From: Mark Thomas <mthomasesq@outlook.com>
Sent: 09 February 2026 15:32:21 UTC+01:00
To: "Joseph Swift" <Joseph.Swift@midsussex.gov.uk>; "Richard Thompson" <rthompson@hadronconsulting.co.uk>
Cc: "Anna Kramarczyk" <Anna.Kramarczyk@midsussex.gov.uk>; "Louise Yandell" <louise.yandell@midsussex.gov.uk>
Subject: RE: DM/25/1175

From: Joseph Swift <Joseph.Swift@midsussex.gov.uk>
Sent: 26 January 2026 13:00
To: Mark Thomas <mthomasesq@outlook.com>; Richard Thompson <rthompson@hadronconsulting.co.uk>
Cc: Anna Kramarczyk <Anna.Kramarczyk@midsussex.gov.uk>; Louise Yandell <louise.yandell@midsussex.gov.uk>
Subject: DM/25/1175

From: Joseph Swift
Sent: 26 September 2025 16:50
To: 'Mark Thomas' <mthomasesq@outlook.com>; Richard Thompson <rthompson@hadronconsulting.co.uk>
Cc: Anna Kramarczyk <Anna.Kramarczyk@midsussex.gov.uk>; Sally Blomfield <Sally.Blomfield@midsussex.gov.uk>; Robert Anderton <Robert.Anderton@midsussex.gov.uk>
Subject: RE: DM/25/0091

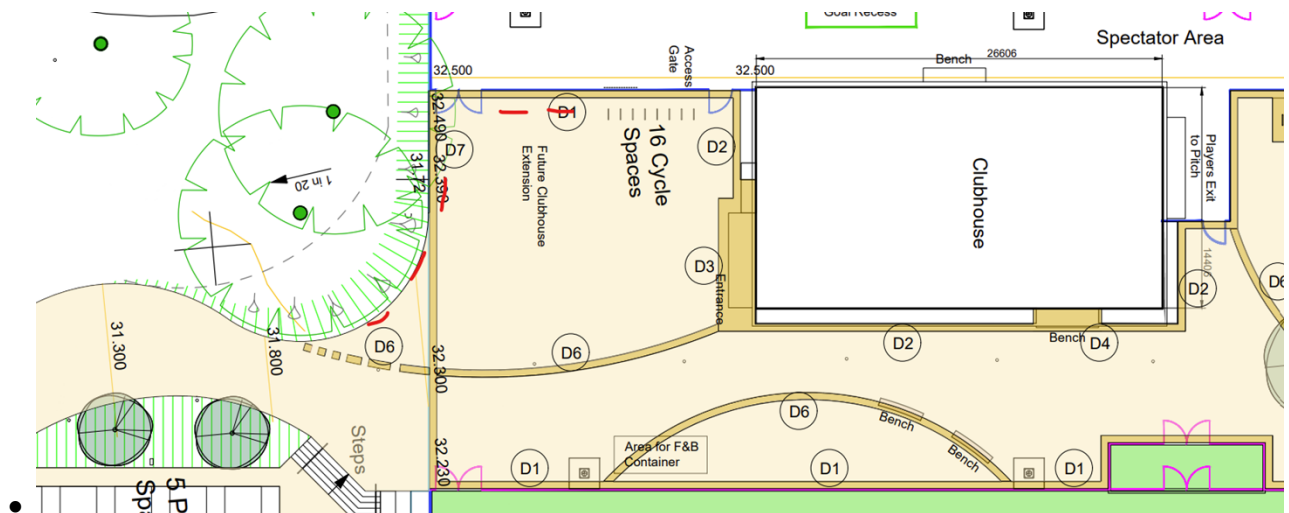
Below is an example of a low cost public seat, made from black composite decking boards. The photos show benches to the front of the farmyard buildings converted to an exhibition centre in Knowth in Ireland.

Composite decking was cut to size and screwed together. The seating cube was sitting on a base which was set back to create a 'shadow gap' between the seat and the pavement (base was also made from the composite decking).

Considering that composite decking is structurally quite effective, and requires zero maintenance it would provide a cheap and effective solution to the problem.

The example shown is obviously too big for the COOS. I would suggest 5 of those, halved in size placed as shown on the screenshot of the plan (marked in **RED** on the plan).

- Detail of the seats is shown on the photos above (self-explanatory).
- There would have to be additional boards inside the cube to stabilise the construction of the cube and make it more robust.
- But these are not required to be attached to the ground and can be moved around the site.
